Glasair Service Bulletin 1

Subject: Nose Gear Scissors

Models Affected: RG Landing Gear #01-70

FIGURE (1-1)

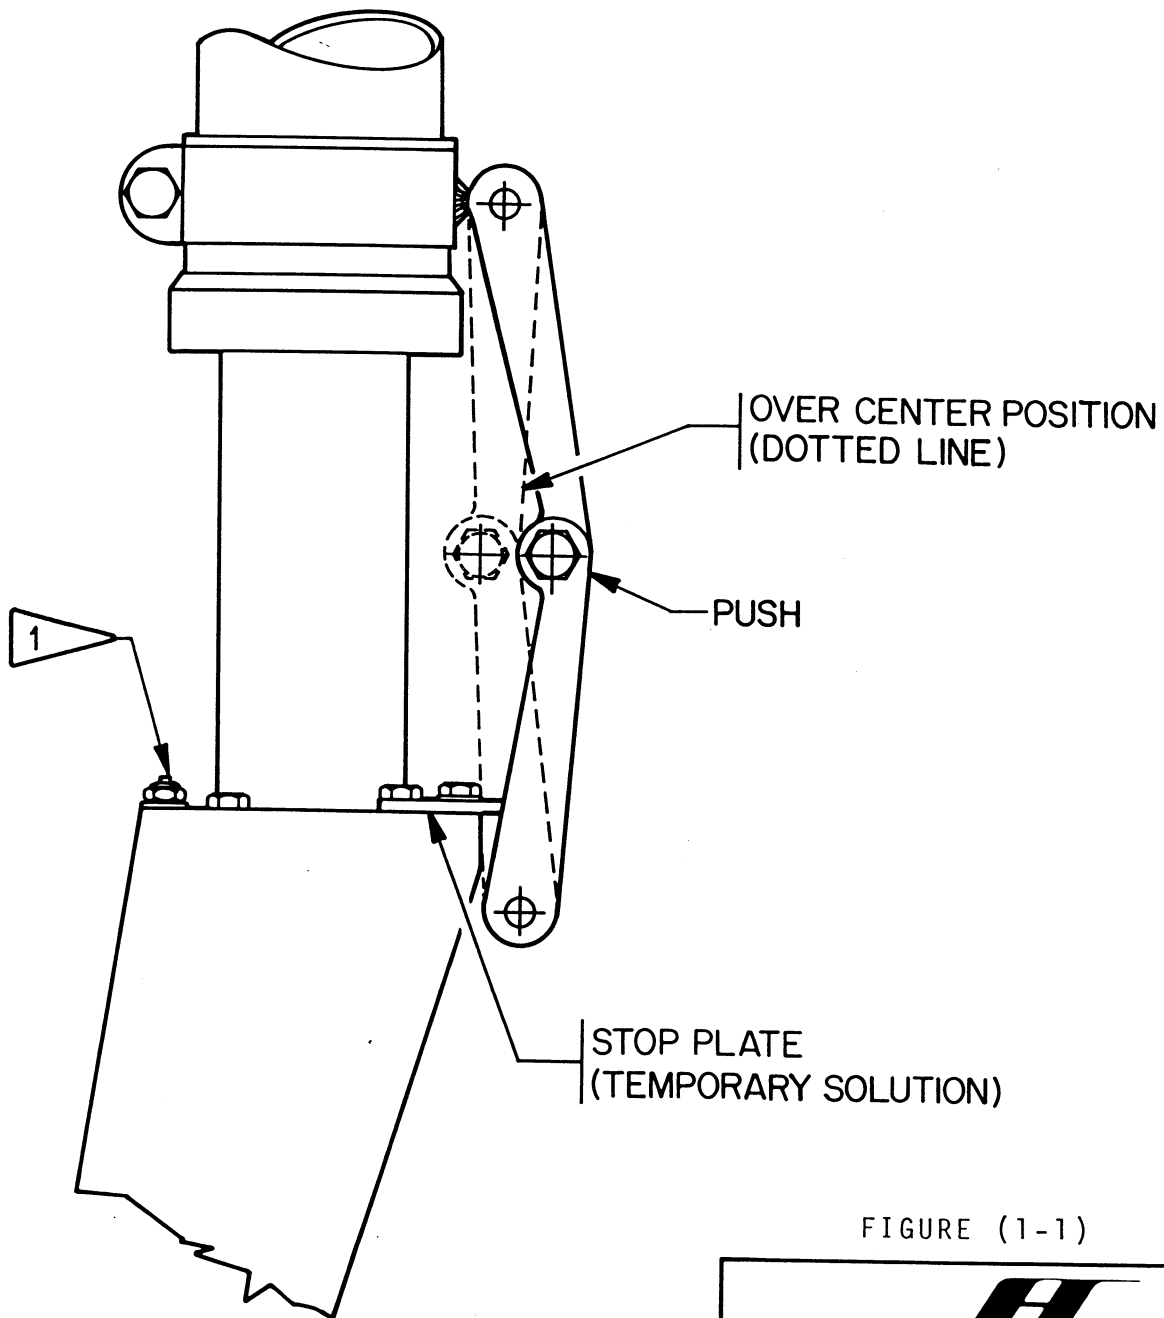
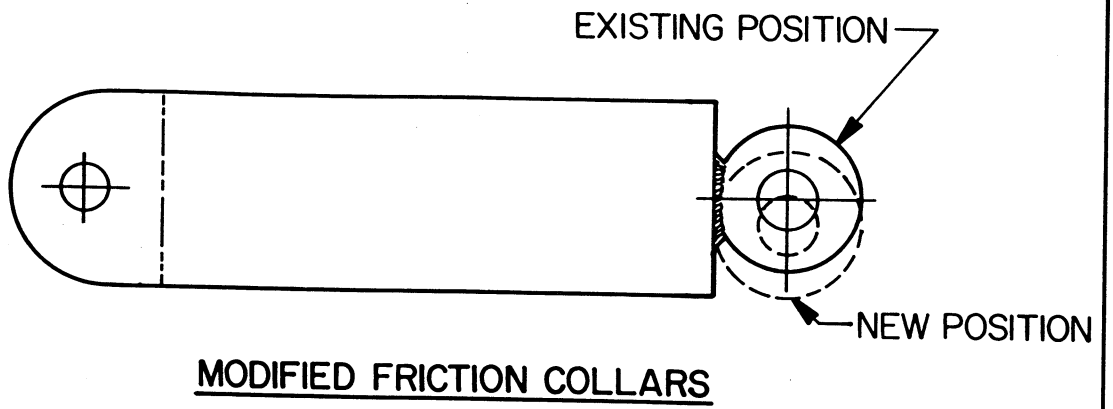
On some of the nose gear struts in the first production run, the upper and lower pivot points for the scissors are too far apart, allowing the possibility of the scissors rotating over center and locking the oleo strut in its fully extended position.

To check your nose gear strut, first bolt the aft ends of the shimmy damper friction collars together using the AN hardware provided, as shown in FIGURE (3-23) on page 3-37 of the RG Appendix. Now, with the strut fully extended, push inward on the center pivot point of the scissors, as shown in FIGURE (1-1), using firm thumb pressure. If the scissors rotate to the over center position, shown by the dotted line in FIGURE (1-1), then a problem exists which must be remedied. Be aware that, with the gear struts fully extended, the nose gear scissors are normally in a flatter position than the main gear scissors, and also that rubber O-rings are used in the oleo struts to cushion the extension stop. So, do not use excessive force to accomplish this test; just use firm thumb pressure.

The aft bolt that holds the nose gear fork to the oleo strut, referenced by Flag #1 in FIGURE (1-1), may rub on the tire. This bolt should already have been installed with the head toward the tire but, in some instances, there is still too little clearance. If this is the case, remove the bolt and countersink the bolt hole (on the side toward the tire) for an AN509-10R14 screw. We will supply the screw, if needed.

If your testing shows a problem to exist with the main gear scissors, we will exchange your shimmy damper friction collars with a modified set on which the scissors boss has been lowered 1/8". The collars can easily be replaced with the nose gear struts mounted on the airplane. These modified parts should be ready for shipment in the near future.

If you planned to have your airplane flying before parts are available, fabricate a stop plate and bolt it to the nose gear fork, as shown in FIGURE (1-1), to keep the scissors from rotating to the over center position. This stop plate can be removed after you receive and install the modified friction collars.

NOTE: In extreme cases all three of the aft bolts will need to be inverted and countersunk.
